**TERRA SEARCH INC.**

RE: **REVISED WORK PLAN**  
Soil and Groundwater Investigation  
3826 Depot Road  
Hayward, California 94545

REVISED WORK PLAN

REVISED  
Figure 3

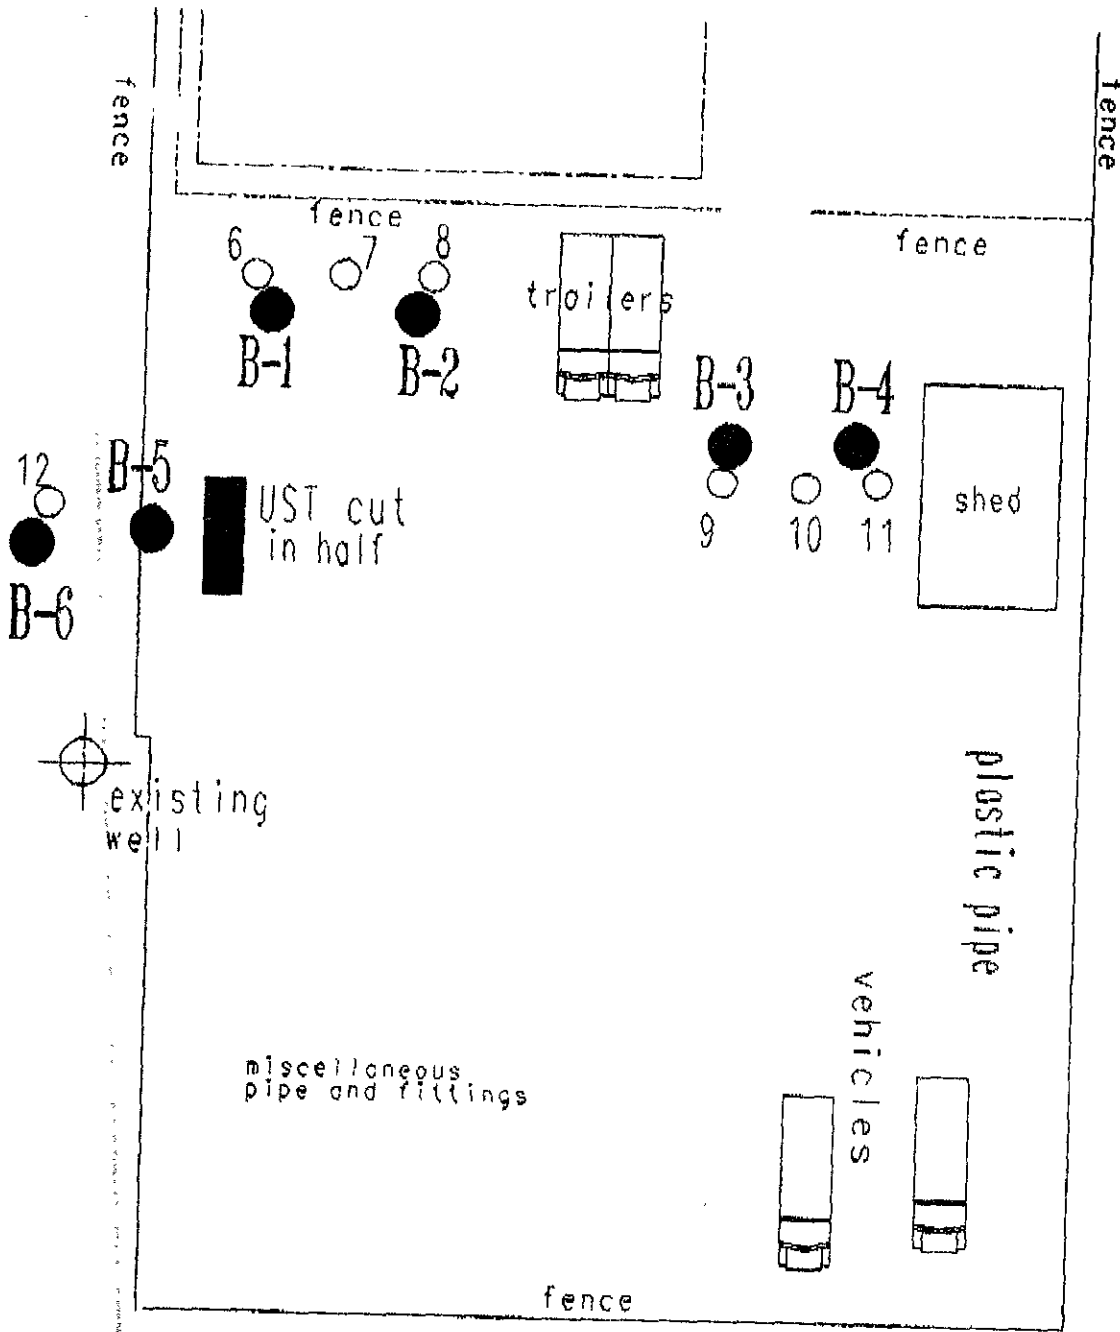
**1. Page 12 of 23**  
**(3 additional borings, sample at 0-0.5-foot depth, contingency remediation)**

**REPLACE** paragraph titled "1. Location and Depth" with the following two paragraphs:

One (1) soil sample would be collected above the water table **from 0-0.5-foot** depth from each of **six (6)** borings. Proposed soil boring locations are shown on **revised** Figure 3 - "Proposed Monitor Wells and Soil Borings Locations" (pertinent portion of Figure 3 attached). The purpose of drilling shallow soil borings would be to collect soil samples for analysis of TPH as diesel and gasoline, and gasoline constituents of BTXE. The borings are proposed in locations where previous soil contamination as TPHd was detected above 100 ppm near where the tanks were washed and torch cut. TPHg and BTXE analyses are proposed because these constituents were detected in the soil and groundwater from where the tanks were excavated.

Three (3) groundwater monitor wells are proposed at locations shown on Figure 3 - "Proposed Monitor Wells and Soil Borings Locations". The proposed depth of each monitor well is approximately fifteen (15)-feet. The purpose of installing three (3) groundwater monitor wells would be to collect soil and water samples for analysis of TPH as diesel and gasoline, and gasoline constituents of BTXE during April, May, and June 1991, and thereafter as directed by ACHCA, and estimate groundwater gradients. The proposed locations of the wells are upgradient (one well) and downgradient (two wells) to the previous diesel tank excavation. The proposed locations were selected by assuming the groundwater gradient to be toward the Bay. Soil samples would be collected at a maximum of five (5)-foot intervals from the surface or at significant changes in lithology.
